SUBDIVISION REVIEW SHEET**CASE NO.:** C8J-2008.0168.01.4A**Z.A.P. DATE:** 11/16/2021**SUBDIVISION NAME:** Entrada Phase 3 A Small Lot Subdivision**AREA:** 18.306 acres**LOT(S):** 91**OWNER/APPLICANT:** Lennar Homes of Texas Land and Construction, Ltd. (Kevin Pape)**AGENT:** Carlson, Brigrance & Doering, Inc. (Brendan McEntee)**ADDRESS OF SUBDIVISION:** Entrada Tranquila Way**GRIDS:** MQ35**COUNTY:** Travis**WATERSHED:** Gilleland Creek**JURISDICTION:** 2-Mile
ETJ**EXISTING ZONING:** N/A**MUD:** N/A**PROPOSED LAND USE:** Single Family, Landscape and Sidewalk**ADMINISTRATIVE WAIVERS:** N/A**VARIANCES:** None**SIDEWALKS:** Sidewalks will be provided on all internal streets.**DEPARTMENT COMMENTS:** The request is for approval with conditions of Entrada Phase 3 A Small Lot Subdivision consisting of 91 lots on 18.306 acres. Water and wastewater will be provided by the City of Austin.**STAFF RECOMMENDATION:** Staff recommends approval of the plat and construction agreement, subject to the conditions listed in the attached comment report. After the conditions are met, the plat will comply with City of Austin Land Development Code, Chapter 30-2-84(B). The conditions include a street name co

SHEET NO. 2 OF 5

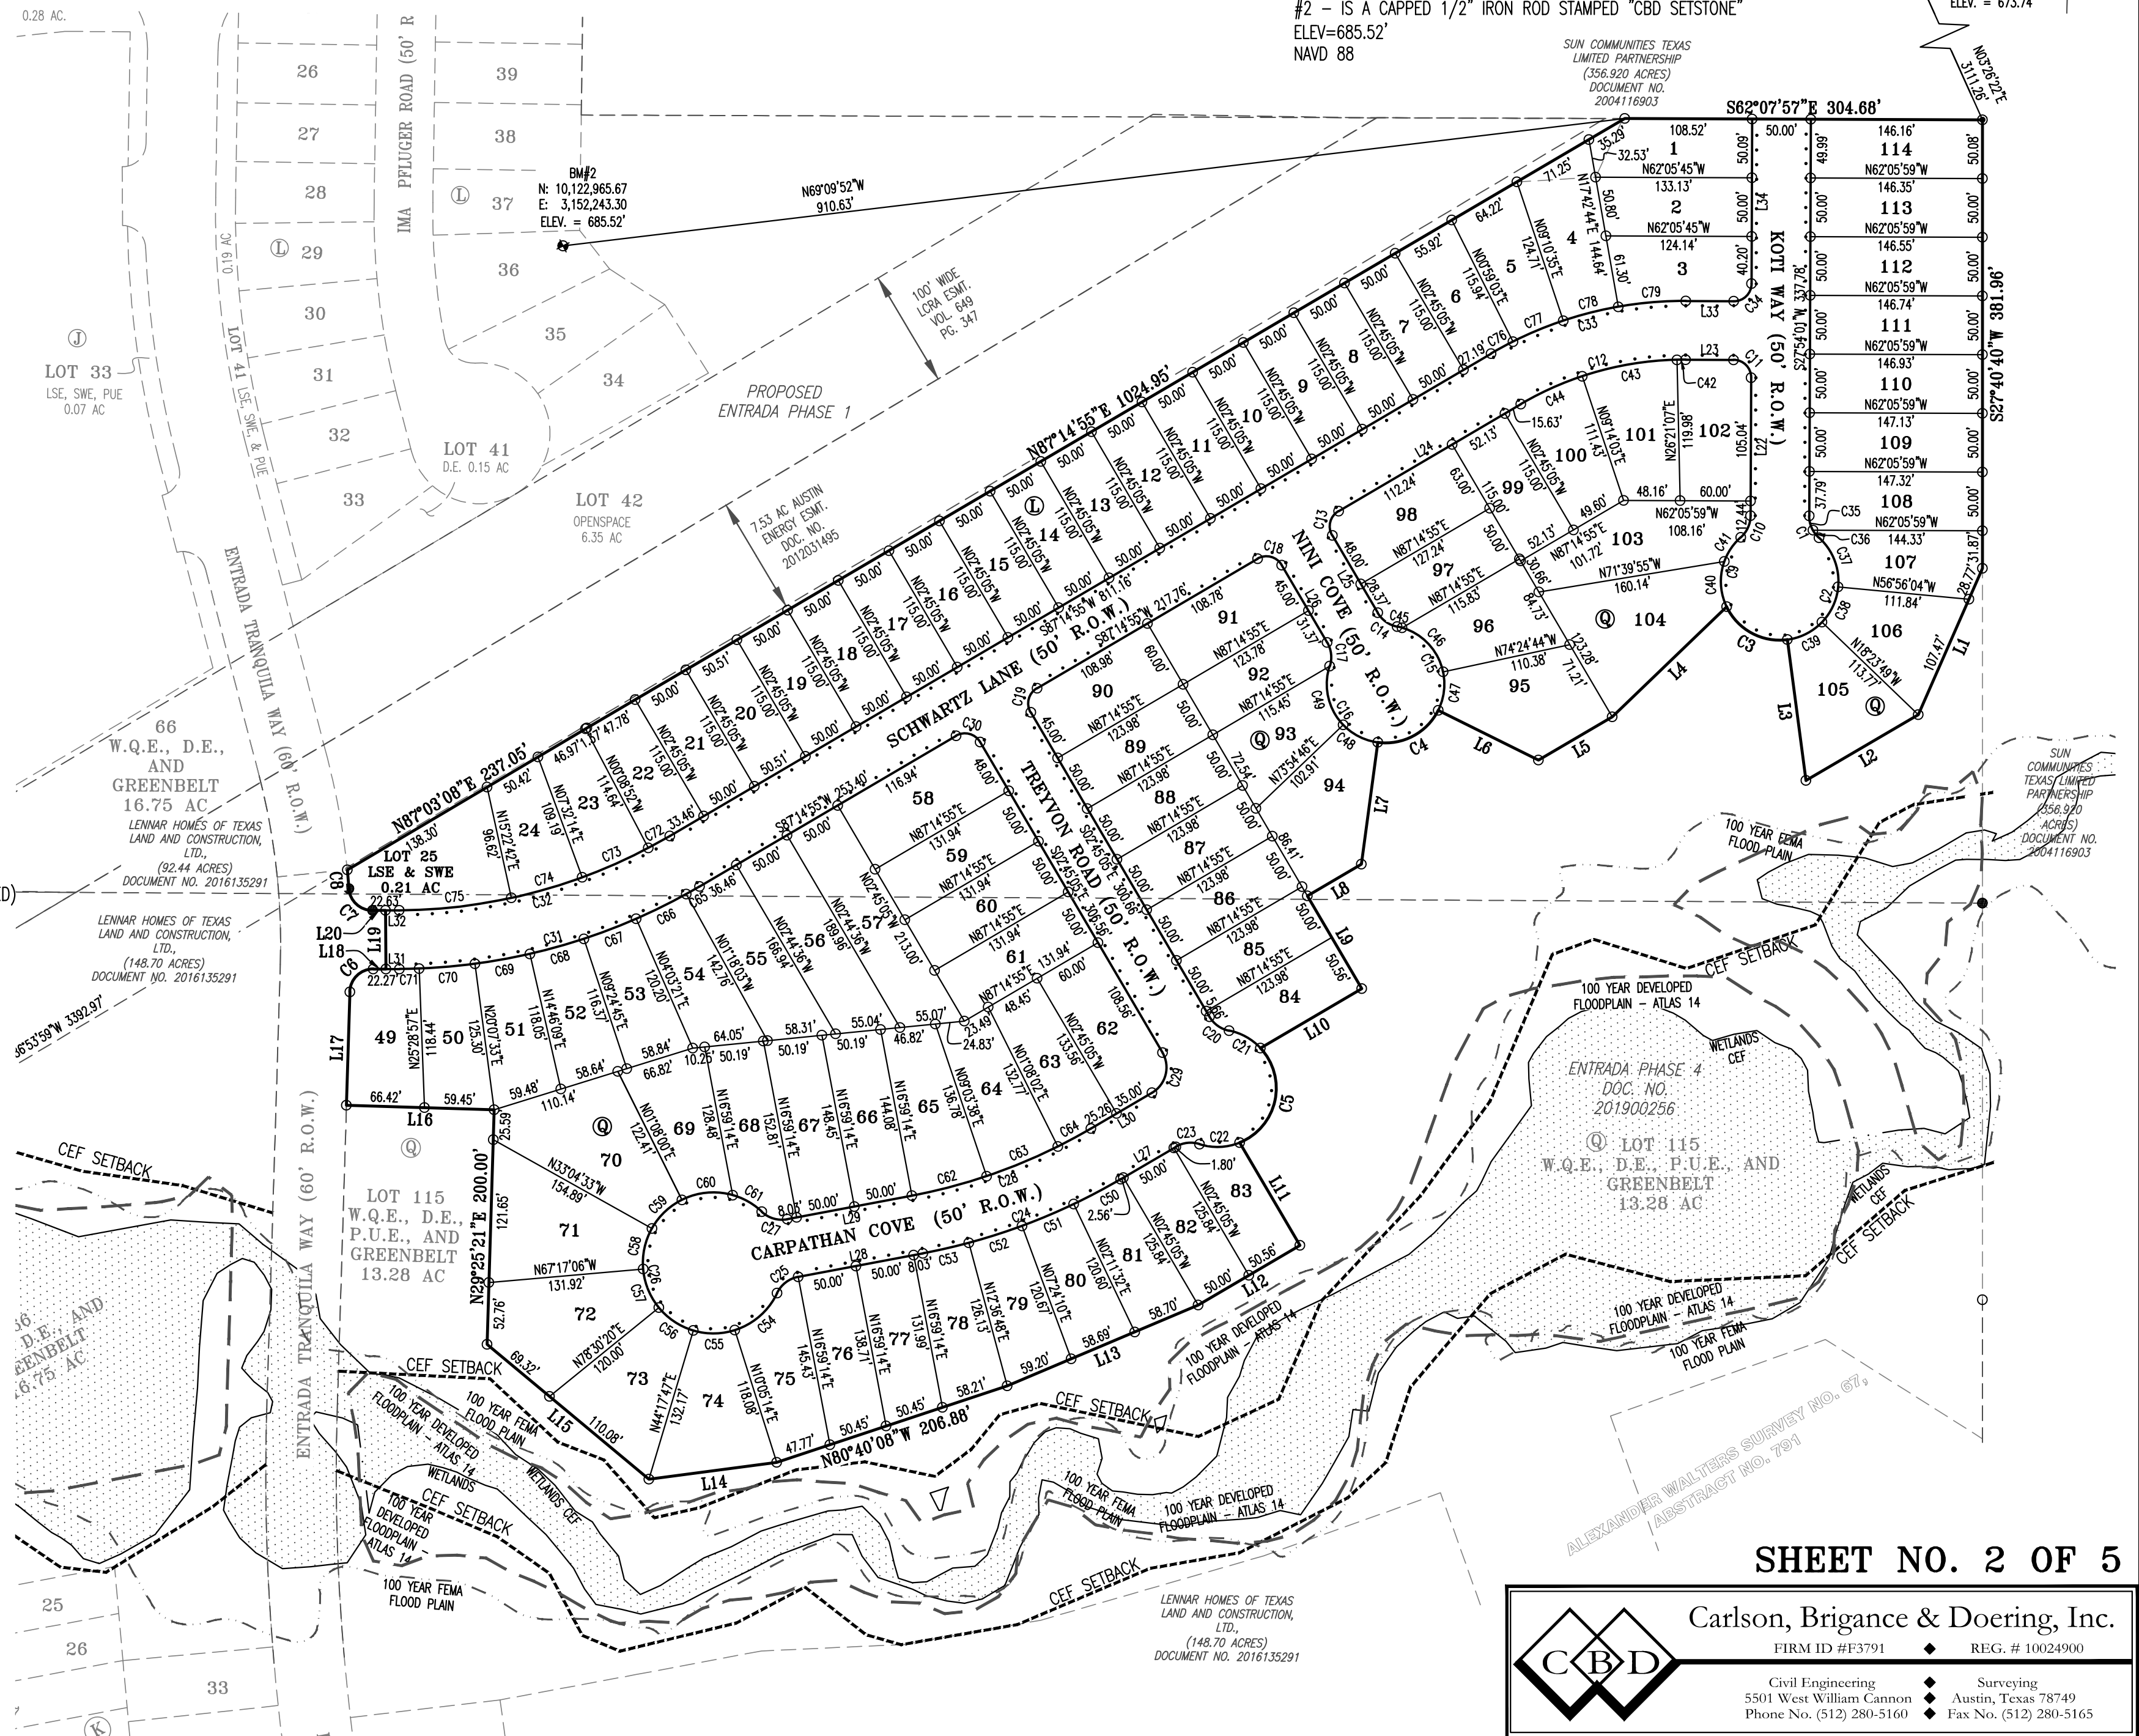
1. Clarify the distance of the CEF setbacks.

Comment not cleared as response is not clear. In addition, please identify all acronyms in future responses.

UPDATE: Comment still pending as there was no response in comment letter.

2. Indicate if any line of sight easements are needed on any of the edge of the single family lots.

3. Label and identify in the Legend the S.W.E. callout.

Comment cleared.

Comment cleared.
